# TECHNICAL SERVICE BULLETIN

**SF – 090 Rev.2**

DATE: **Month xx, 2022**  
 TO: All Service and Parts Managers  
 SUBJECT: Field modifications required for certain evaporator coil drain pans paired with condensing furnaces in upflow applications

TSB-OT-0016

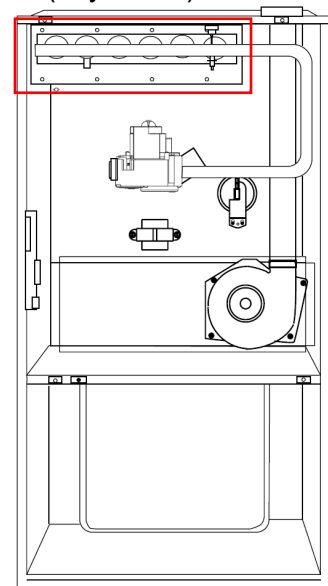
- a. **ONLY** applies to heat exchanger configurations where burner input is located **at the bottom**. If burner input is located at the top of the heat exchanger (as shown in picture to the right) the furnace is **not exempt** and will require further action.
3. A metal reinforcement is observed below the drain pan of the coil. This indicates modifications have already been performed on the specific coil.
4. The matched furnace is a Daikin, Goodman, or Amana® brand Ultra Low NOx gas furnace.
5. The matched furnace is a Daikin, Goodman, or Amana brand condensing furnace with a constant volume (variable speed ECM) from the model number families listed below in **Table 2**.
6. The matched furnace has a Blower Guard Kit. This indicates that modifications have already been performed on the specific system.

1. System with the in-scope coil/drain pan service part is matched to Heat Pump outdoor unit (not Air Conditioner)  
**\*\*\*UPDATE\*\*\***
2. In-scope coil/drain pan service part is matched with any brand other than Goodman, Amana, or Daikin condensing gas furnace or non-condensing furnace with the burners at the top of the heat exchanger as shown on page 2 and is installed in an upflow orientation. If burner location is unknown, visual verification may be required.
3. In-scope coil/drain pan service part is matched with a Goodman or Amana brand condensing gas furnace not listed in **Table 2** or **Table 3**, and is installed in an upflow orientation

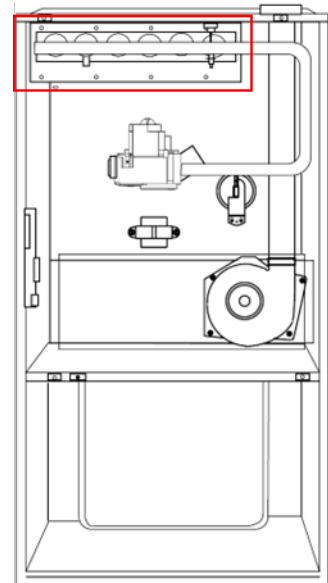
- a. **ONLY** applies to heat exchanger configurations where burner input is located **at the bottom**. If burner input is located at the top of the heat exchanger (as shown in picture to the right) the furnace is **not exempt** and will require further action.
3. A metal reinforcement is observed below the drain pan of the coil. This indicates modifications have already been performed on the specific coil.
4. The matched furnace is a Daikin brand Ultra Low NOx gas furnace.
5. The matched furnace is a Daikin brand condensing furnace with a constant volume (variable speed ECM) from the model number families listed below in **Table 2**.
6. The matched furnace has a Blower Guard Kit. This indicates that modifications have already been performed on the specific system.

2. In-scope coil/drain pan service part is matched with any brand other than Daikin condensing gas furnace or non-condensing furnace with the burners at the top of the heat exchanger as shown on page 2 and is installed in an upflow orientation. If burner location is unknown, visual verification may be required.
